# **A38 Derby Junctions Development Consent Order**

**Scheme Number TR010022**

## **8.36 Applicant's Comments on any Additional Information or Submissions Received by Deadline 1**

November 2019

**Figure 1.1: Extent of the 2D direct rainfall model in the Breadsall area, showing modelled baseline and proposed watercourse alignments, flow estimation points and flooding location alluded to in DCC's response**

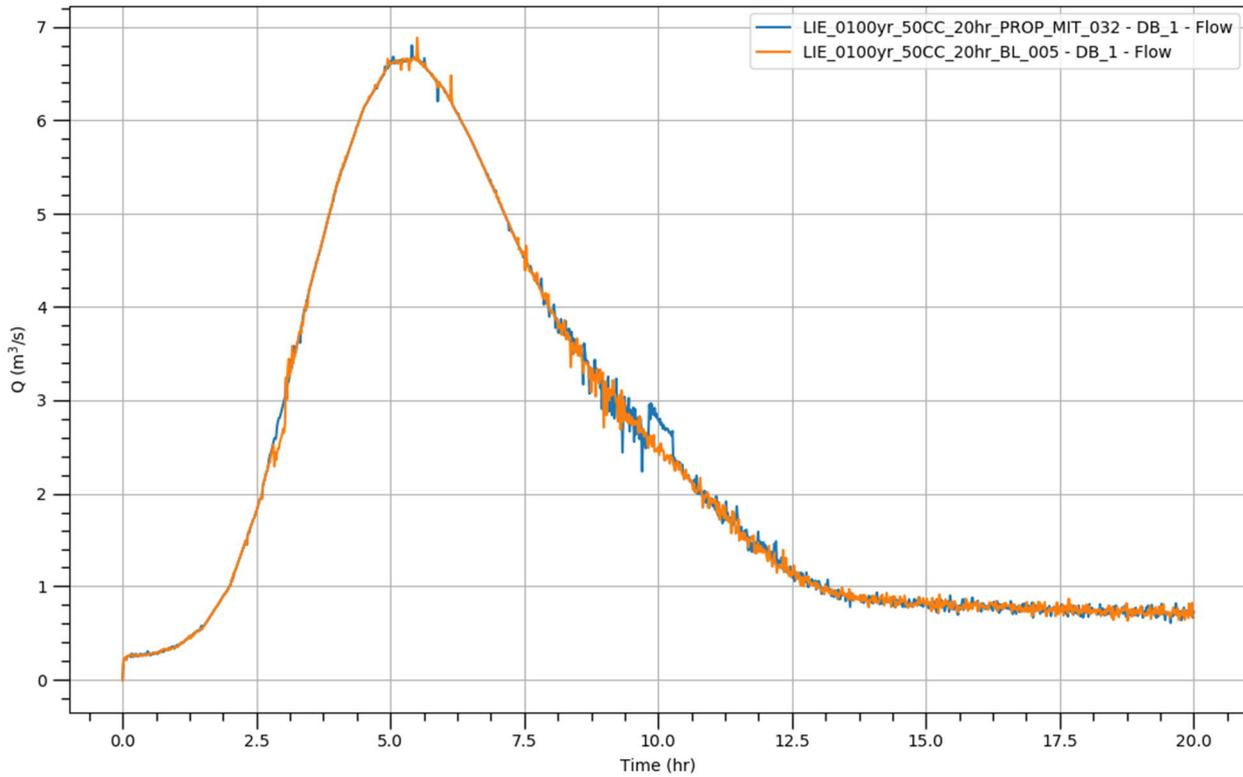
Highways England has confirmed that the Dam Brook diversion and realignment works would not result in increased flood risk to properties in Breadsall upstream of the Scheme. Derbyshire County Council (DCC), however, note that no details to support this conclusion have been provided. As such, this Technical Note has been produced to provide further details of model results, which illustrate the expected impacts of the Scheme on Dam Brook and Boosemoor Brook at Breadsall village, upstream of the Scheme.

Figure 1.1 highlights the extent of the Little Eaton/Breadsall surface water model that was constructed to inform the Little Eaton Flood Risk Assessment [APP-231]. The modelled representation of Dam Brook has an upstream extent at the western boundary of Brookside Road. It does not include the culvert which conveys flows under Brookside Road. The modelled representation of Boosemoor Brook has an upstream extent slightly west of Rectory Lane (close to Rectory Farm). The Rectory Lane culvert has not been represented in the Little Eaton model. Further information on this modelling can be found in the Little Eaton Surface Water Modelling Technical Note, which forms Appendix D of the Little Eaton Flood Risk Assessment [APP-231]. DCC's Written Representation [REP1-030] has noted that Dam Brook and Boosemoor Brook have flooded previously, where they are culverted under Brookside Road and Rectory Lane respectively (see Figure 1.1).
